LINCOLN CITY/LANCASTER COUNTY PLANNING STAFF REPORT

-REVISED STAFF REPORT-

P.A.S.: Special Permit #1999A for Community Unit Plan.

PROPOSAL: To amend the Wilderness Hills CUP by adjusting the rear setback down to 0' for Lots 9-23, Block 2, and down to 5' for Lots 8-34, Block 7; waiving the maximum lot width to depth ratio; waiving the minimum lot depth; and, allowing double-frontage lots for an attached single-family and townhome development of approximately 66 units between Wilderness Hills and Whispering Winds Blvds.

KEYSTONE VILLAGE

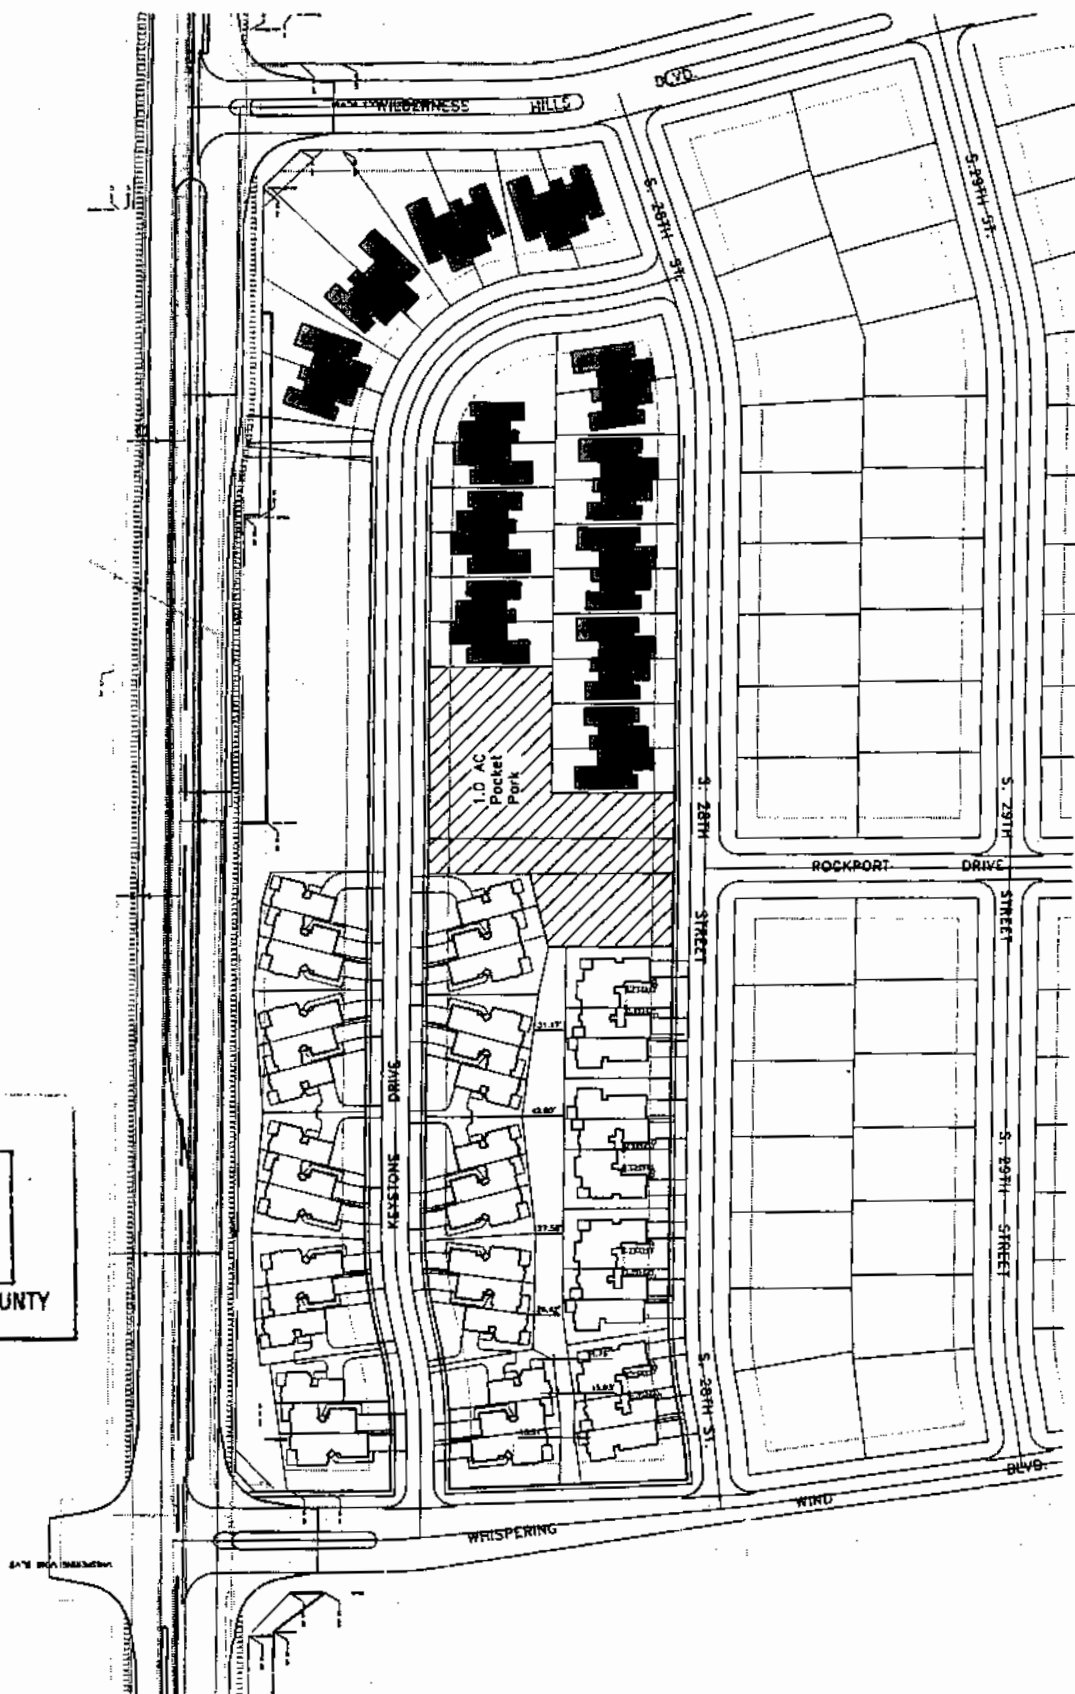
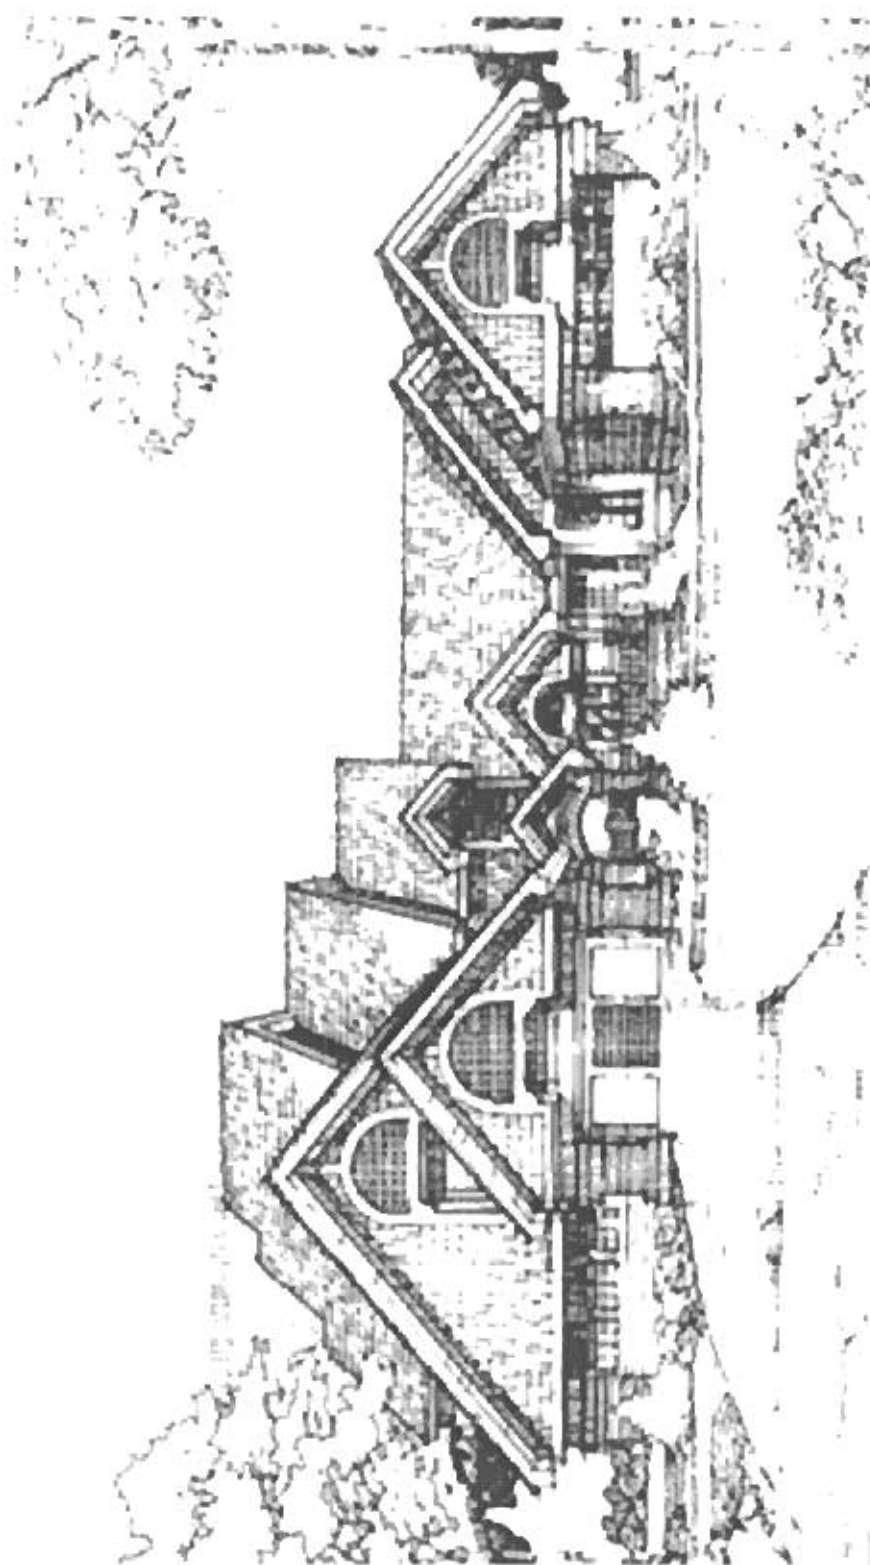
4. To facilitate pedestrian access to the adjacent arterial street sidewalk system, and to the pocket park shown in Outlot D and the open space in Outlot C, a sidewalk should be extended across both Outlots C and D to South 27th Street in line with Rockport Drive.

5. The application requests five waivers (each is discussed individually below):
 - A. Waive the maximum allowed block length - As measured, the block length is actually less than 1,320' and a waiver is not required.

- B. Allow double-frontage lots - This request applies to Lots 1-5, Block 2. Screening consistent with the Design Standard for lots backing onto streets (Chapter 3.50, Section 7.4) is required. To mitigate double frontage, any fence erected along the rear property lines should be buffered by landscaping that is planted between the fence and the street in an amount at least equal to a 50% screen to 6' in height.

- C. Allow lots less than 120' in depth along arterial streets - This waiver applies to Lot 8, Block 2, which has an average lot depth of 116'. The lot depth was reduced after a 15' dedication of right-of-way to allow for a right-turn lane off South 27th Street at Wilderness Hills Blvd, and the reduction is not significant. However, a note must be added to clearly label the land to be dedicated as right-of-way near the intersection of South 27th Street and Wilderness Hills Blvd.

- E. Adjust the rear setback for Lots 9-23, Block 2 down to 0', and down to 5' for Lots 8-34, Block 7 - This waiver was not requested as part of the original CUP, and cannot be approved administratively. For Lots 9-23, which are those lots between South 27th Street and Keystone Drive, Outlot F separates them from South 27th Street. This outlot varies from approximately 15' to 45' in width. The developer is proposing to create this outlot so that a uniform landscape screen can be controlled and maintained along South 27th Street. Staff has met with the applicant and is recommending this setback be adjusted to 5' instead of 0'. This will provide a minimum effective setback of 20'

For Lots 8-34, which are the lots between Keystone Drive and South 28th Street, the request is to adjust the rear setback down to 5' to allow for a common open space at the rear of the lots. This open space is in an outlot, and varies in width from approximately 13' to 42'. The setback combined with the outlot serve to provide adequate open space and separation in this area.

7. A landscape screen is required for Lots 1-8, Block 2 (modified for Lots 1-5 as noted in paragraph 5(B) above) because they back onto a street. However, Lots 9-23, Block 2 are not adjacent to a street, and a landscape screen is not required. As the waiver to the rear setback is requested for Lots 9-23 to provide for a uniformly landscaped area, the site plan should show at least the minimum screening required for lots adjacent to a major street (50% to 6' in height). Additional screening/landscaping can be installed, but this will ensure an adequate amount is provided in Outlot F.

- 1.1.1 Revise the references in General Notes #22 and #23 and in CUP Site Note #7 from "Two-family" to "Single-family Attached."
- 1.1.2 Revise the Waiver Table by deleting waivers #1 and #5, and by amending #6 and #7 to note that the rear setback for Lots 9-23, Block 2 and Lots 8-34, Block 7 is adjusted to 5'.

- 1.1.5 Show a sidewalk extending across both Outlots C and D connecting the sidewalk along South 27th Street to the sidewalk along South 28th Street in line with Rockport Drive.

- 1.1.6 Add Note #10 to CUP Site Notes that reads "THE LANDSCAPE SCREEN ALONG SOUTH 27TH STREET WILL MEET OR EXCEED THE REQUIREMENTS OF THE CITY OF LINCOLN DESIGN STANDARDS, CHAPTER 3.5, SECTION 7.4. SCREENING FOR LOTS 1-5, BLOCK 2 MUST ALSO MEET OR EXCEED THAT STANDARD, AND IF A FENCE IS ERECTED ALONG REAR PROPERTY LINES PLANTS MUST BE INSTALLED BETWEEN THE SIDEWALK AND THE FENCE TO PROVIDE A MINIMUM 50% SCREEN TO 6' IN HEIGHT. THE PROPERTY OWNERS OF EACH LOT MUST MAINTAIN THE PLANTS."

- 1.1.7 Show the additional easements per the L.E.S review.
- 1.1.8 Revise the typical street cross sections to include sidewalks.

- 1.1.9 Label the area along South 27th Street near the intersection with Wilderness Hills Blvd to be dedicated as right-of-way
 - 1.2 Make revisions and corrections noted in the Public Works and Utilities' review to the satisfaction of Public Works and Utilities.
 - 1.3 Make revisions and corrections noted in the Parks and Recreation Department's review.
 - 1.4 The street name change to Keystone Drive must be approved by the Street Name Committee.
 - 1.5 Revise the legal description on Sheet 18 of 18 to include the names of the I.T. lots involved in Special Permit #1999A for the Wilderness Hills community unit plan.
2. This approval adjusts the rear setback for Lots 9-23, Block 2 and Lots 8-34, Block 7 to 5', waives the minimum lot depth for Lot 8, Block 2, and allows Lots 1-5, Block 2 as double frontage lots for Wilderness Hills CUP.
